SIB 51 21 21

2021-10-25

RECALL 21V-831: REAR LICENSE PLATE ILLUMINATION

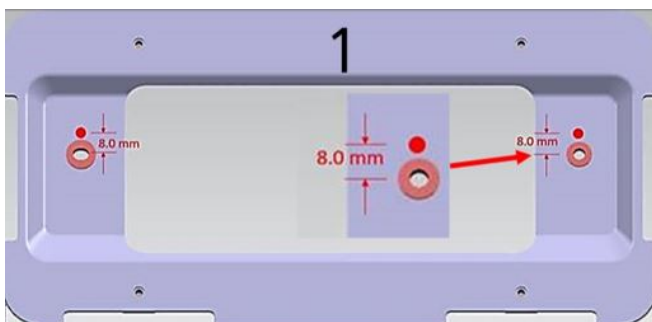
2. Inspect the 2 mounting screws of the rear license plate bracket as shown to the left.

Are both mounting screws installed ABOVE the traditionally used metal bushings?

4. Using a 5mm drill bit, drill 2 new holes exactly 8mm directly above the metal bushings as shown to the left.

5. Reinstall the rear license plate bracket using the 2 new holes, tightening to 1.12 Nm.

Note: The screw heads may now impact the metal bushings when tightened. This is OK.
